# **HILLSIDE MINING LEASE PROPOSAL AND MANAGEMENT PLAN: A RESPONSE**

**Yorke Peninsula Land Owners' Group  
8<sup>th</sup> November 2013**

Figure B.5.4: Predicted maximum 24-hour PM<sub>10</sub> Concentration (Mine Operations) – including background concentration

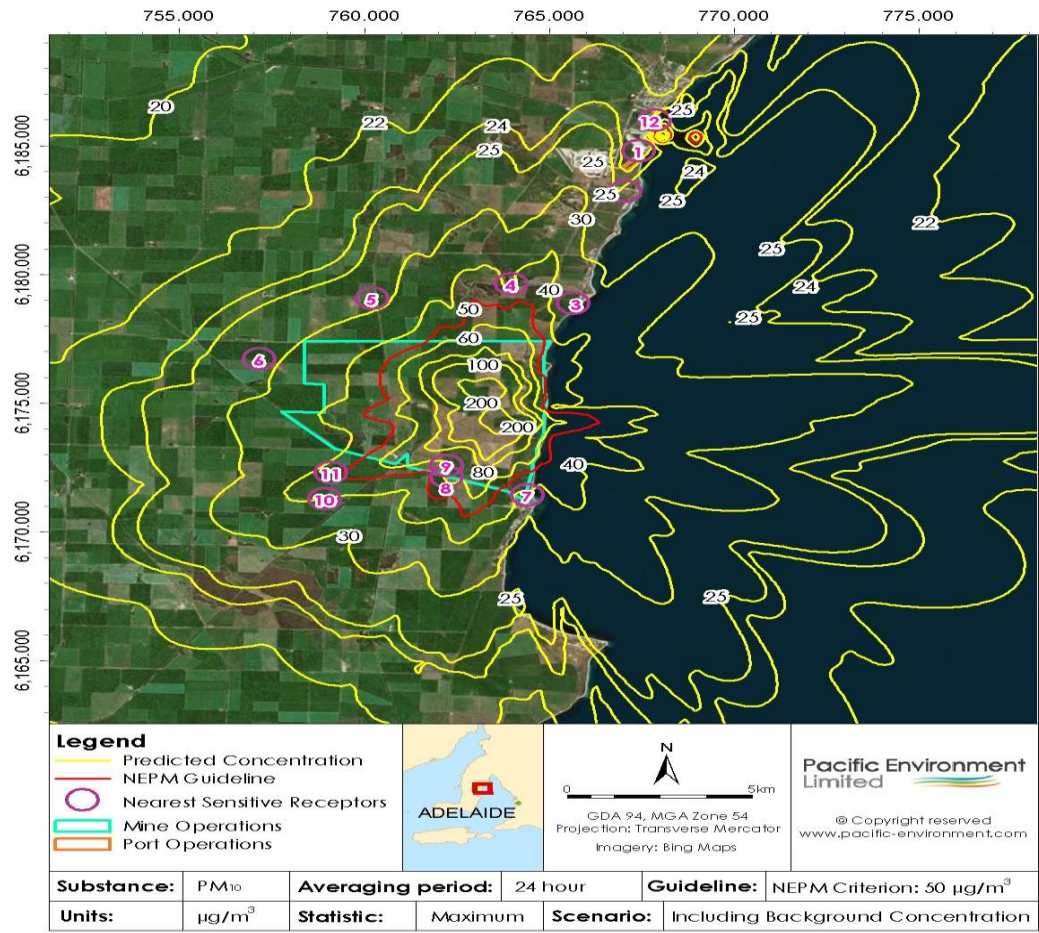
- Rex Minerals' Dust Predictive Map (Figure B5.4, based on full production for all days with no limitations on operations, and **all 'so-called' dust controls applied** shows maximum levels of dust that would be experienced in a 24 hour period. As shown, PM<sub>10</sub> emissions extend from the north of Ardrossan township, covering a wide area to the south of Black Point, moving inland and also extending well into the Gulf, raising issues of sea water contamination from dust settling on the surface of the water.

These predictions seem highly questionable given that baseline data found that NEPM air quality standards were exceeded on **6** occasions during 2012 as a result of strong northerly winds. And these high levels occurred without the 1.4 million tons of dust that the mining operation will generate.

Given this huge amount of additional dust generated by the mine, it is highly unlikely that there will be only three days of 'extreme climatic conditions'. Yorke Peninsula has far more than only three or six windy days per year as evidenced by the winds that have buffeted the region in the last month or so.

- **How much more dust (especially PM10) will local communities (notably Pine Point, Rogues Point, James Well and Black Point) as well as surrounding farms actually experience compared with the baseline situation? More specifically:**
- **On how many days will PM10 concentrations approach or actually reach the maximum 24 hour levels depicted in Figure 8.5.4?**
- **On how many days will increased levels (compared with pre-mining days) be experienced?**
- **What is the average level of PM10 concentrations that we can expect?**
- **On how many days will that average be exceeded?**
